**49 CFR Parts 571 and 585
Federal Motor Vehicle Safety Standards;
Head Restraints; Final Rule**

DEPARTMENT OF TRANSPORTATION**National Highway Traffic Safety Administration****49 CFR Parts 571 and 585****[Docket No. NHTSA–2007–27986]****RIN 2127–AJ96****Federal Motor Vehicle Safety Standards; Head Restraints****AGENCY:** National Highway Traffic Safety Administration (NHTSA), DOT.**ACTION:** Final rule; response to petitions for reconsideration.

SUMMARY: This document completes the agency's response to petitions for reconsideration of the December 2004 final rule upgrading our head restraints standard. We are partially granting and partially denying the petitions.

Figure 1. Risk of Whiplash Injury versus Head to Torso Rotation on the Hybrid III 50th percentile male dummy

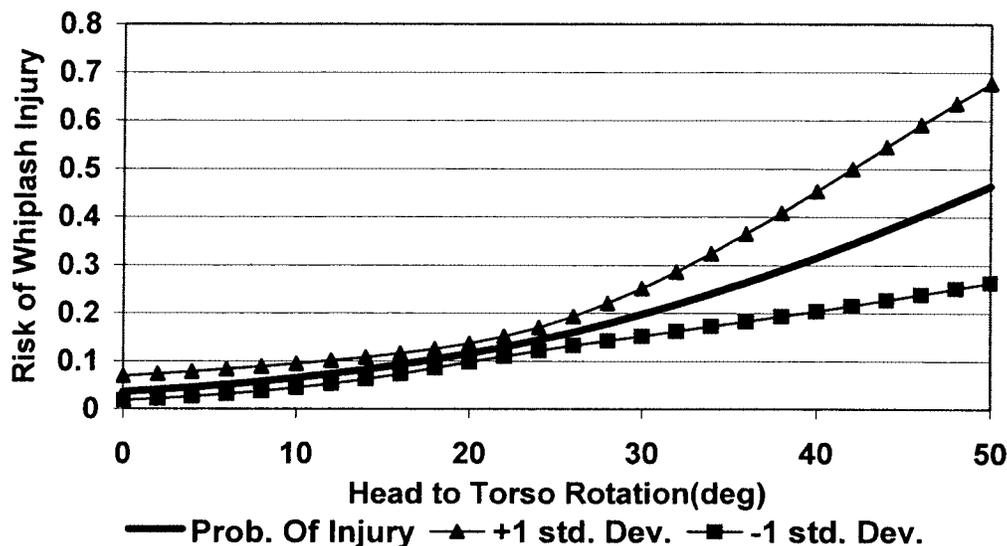
Unfortunately, the agency incorrectly presented in the final rule preamble a graph of head displacement rather than

head rotation (69 FR at 74874). The graph should have been the following:

This correct graph addresses some of the questions raised by the petitioners.

Figure 4 of §571.202a – Portion of gap above 540 mm height.

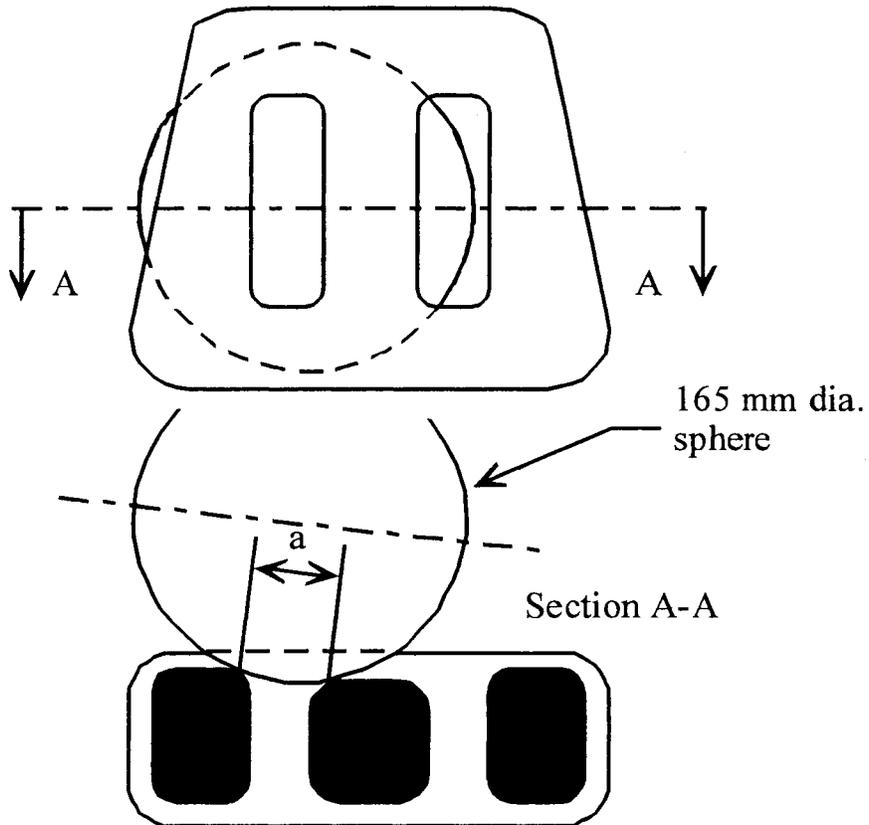
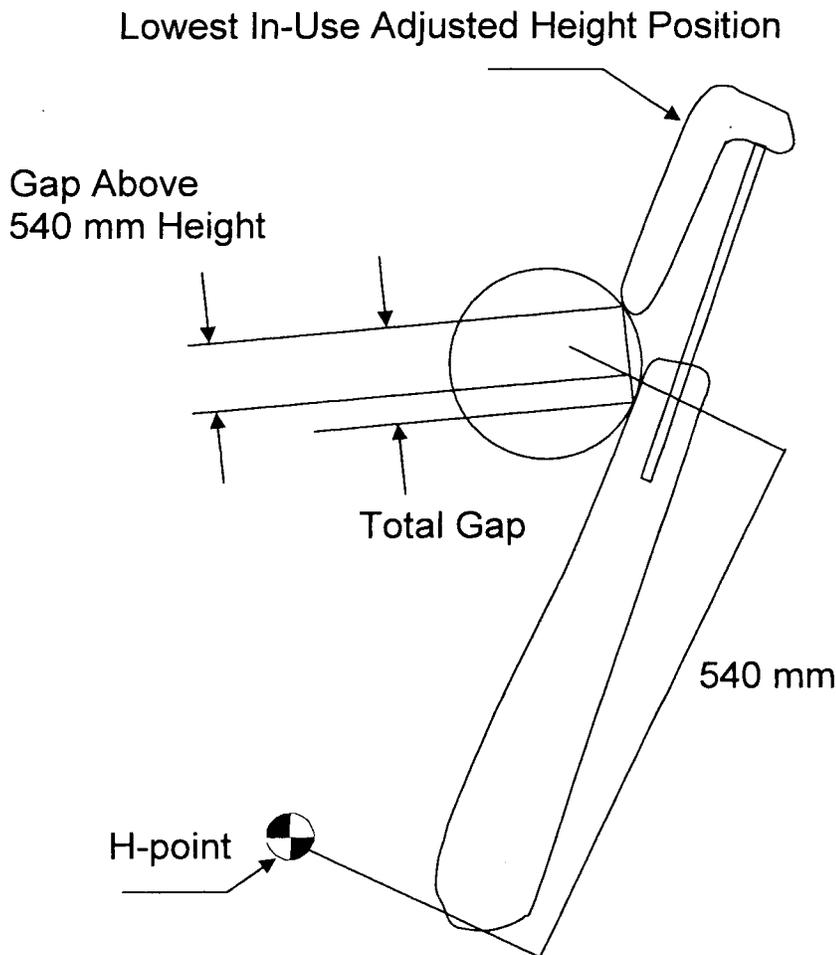
Also, we are adding a new Figure 4 that we believe will help clarify the requirement when using the sphere.
